GROOT LETABA RIVER WATER DEVELOPMENT PROJECT (GLeWaP)

Preliminary Design of the Raising of Tzaneen Dam

VOLUME 7

MAY 2010

**Figure A4.1 Stage Discharge Curve for Labyrinth Spillway**

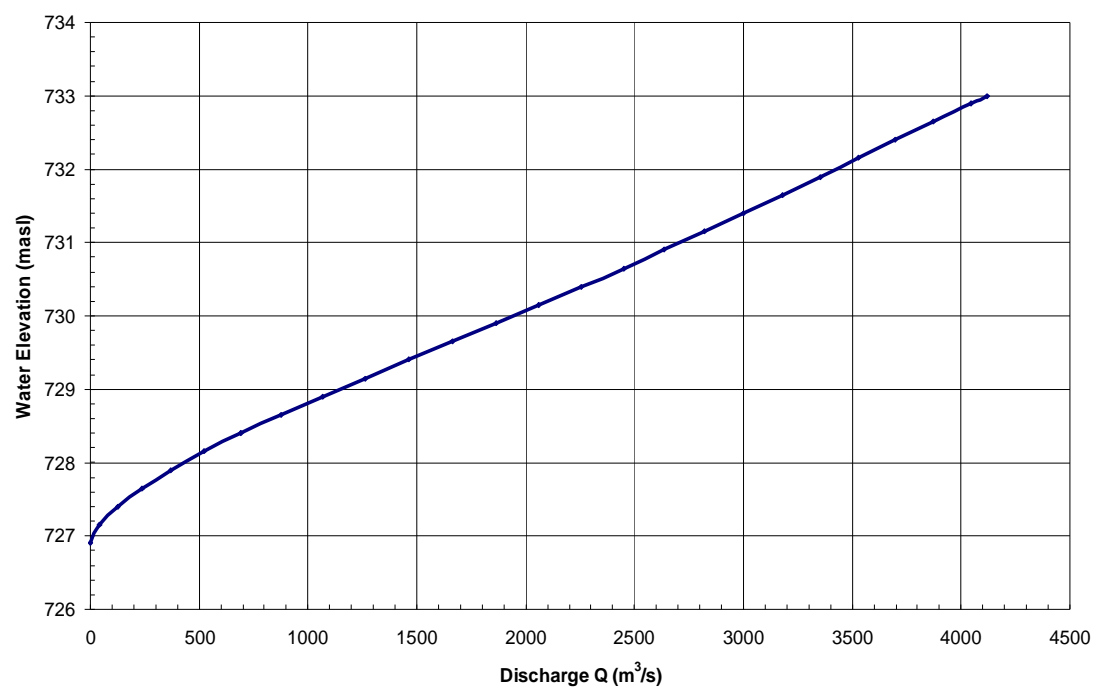
- The 100-year flood should be 1170 m³/s, not 1070 m³/s as given in the bulleted figures after Figure A4.1.
- The inflow and outflow hydrographs for the 100-year and 200-year floods should also show the maximum reservoir level for those floods. These maximum levels should also be given in the report text.

- Designation of RI *Corrected text*
- RDD/RDF terminology *Disagree – RDD refers to unrouted flood peaks
RDF refers to routed flood hydrograph peaks*
- SED/SEF terminology *Disagree – SED refers to unrouted flood peaks -
SEF refers to routed flood hydrograph peaks –
defined as compromise between PMF and RMF
approaches – see Section 3.2*
- Appendix A3.2 - floods *Added note re routing for labyrinth option*
- Appendix A4.2 *Corrected 1 in 100 year RI flood peak*
- Appendix A4.2 *Added water levels*
